# REGIONAL REVIEW FINDING

ARC REVIEW CODE: R710261

**Submitting Local Government:** City of Atlanta  
**Name of Proposal:** Morningside Redevelopment

**Review Type:** Development of Regional Impact

**GRTA DRI SITE PLAN**

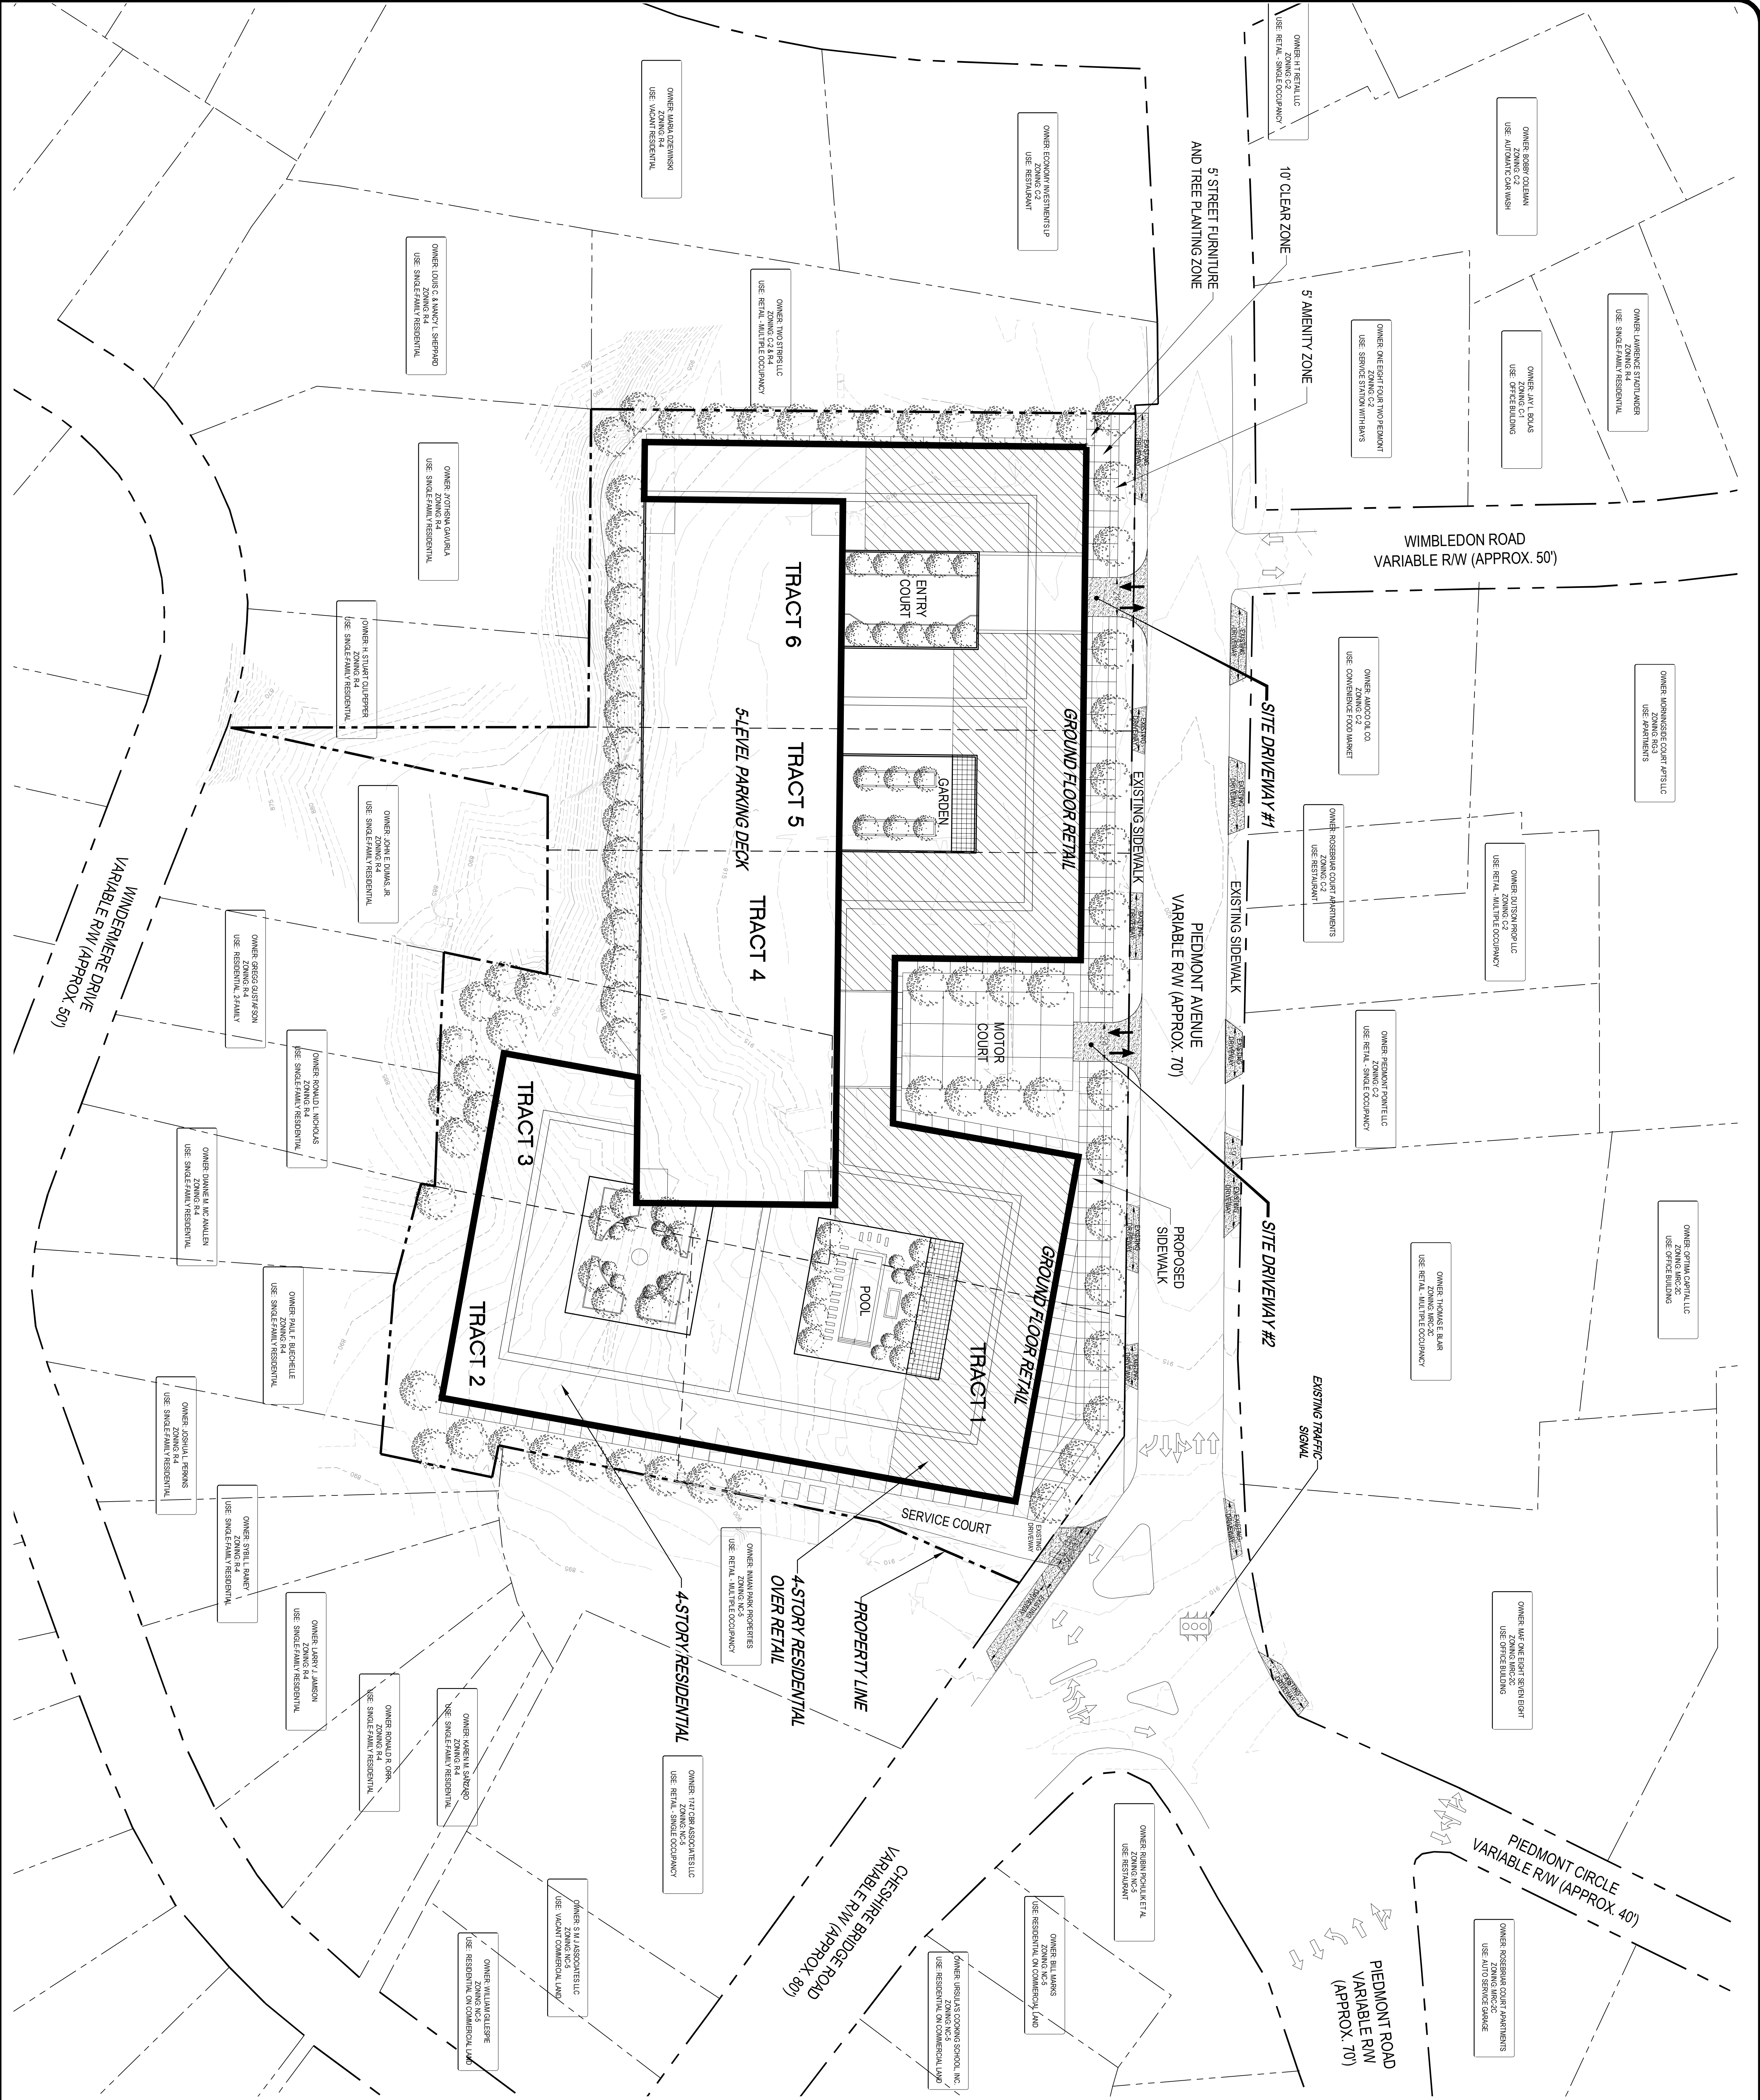
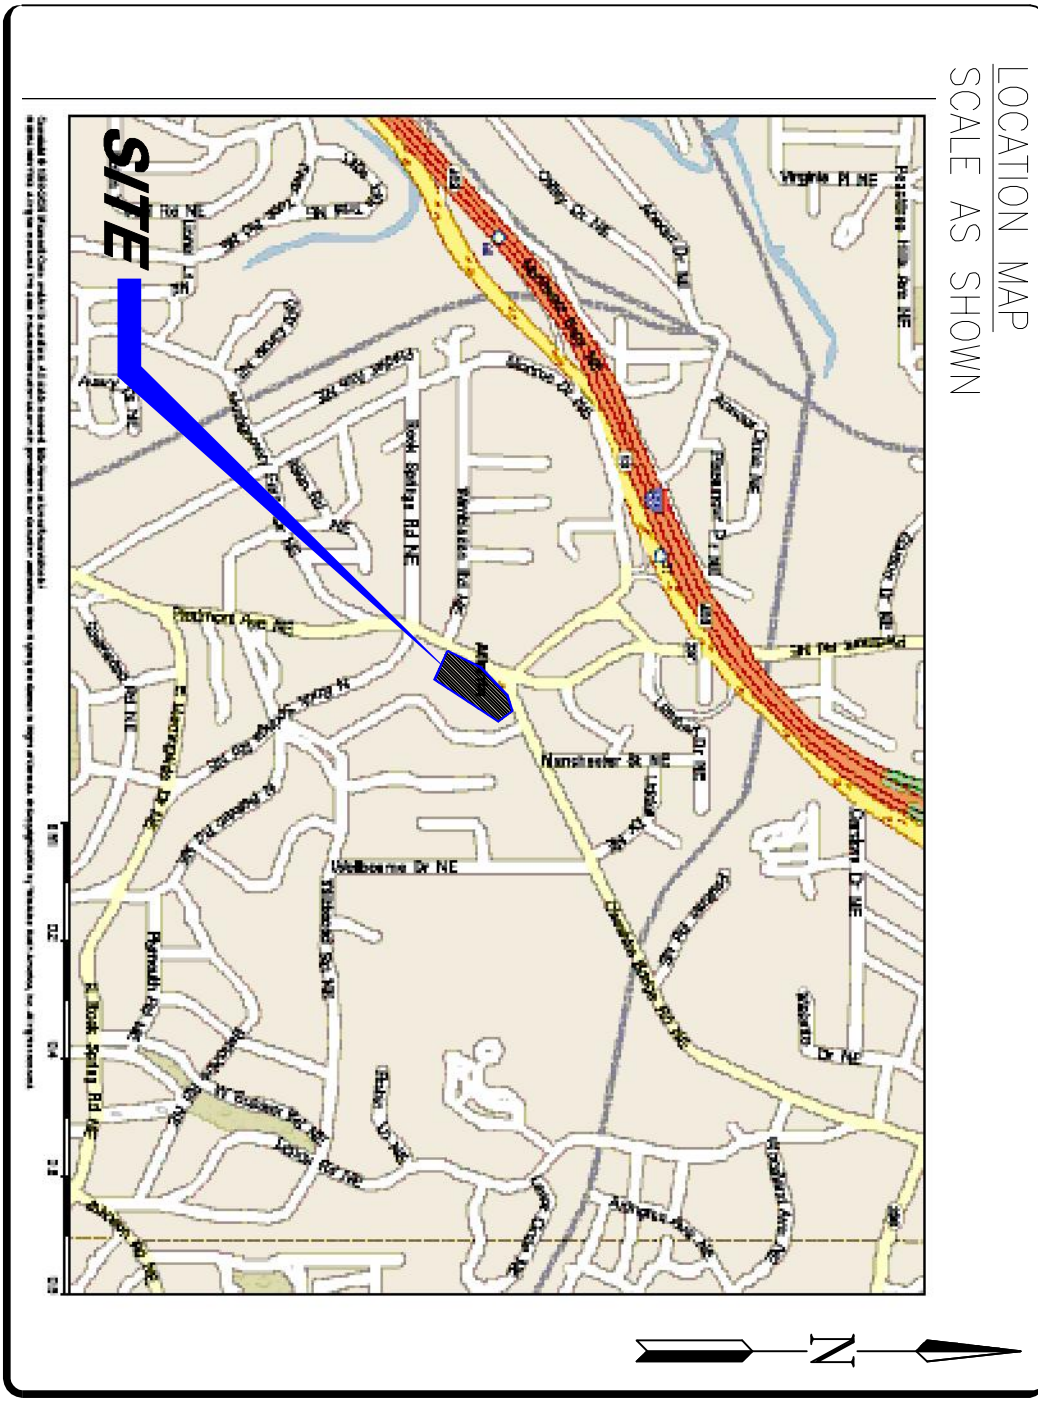
Comments received from the City of Atlanta state that the proposed service driveway at the intersection of Cheshire Bridge and Piedmont Avenue will be closed to vehicular traffic. Nationally recognized access management principles strongly warn against allowing driveways in the functional area of an intersection due to potential safety and operational problems. As such, ARC recommends the service driveway at this intersection be eliminated. Additional access management principles should be applied along Piedmont, such as site driveway #1 should align with Wimbledon Avenue.

- Align Wimbledon Road with proposed entrance on Piedmont Road
- The existing service court at the intersection of Piedmont & Cheshire Bridge Road will be closed to all vehicular traffic
- Detail proposed loading for development on site plan
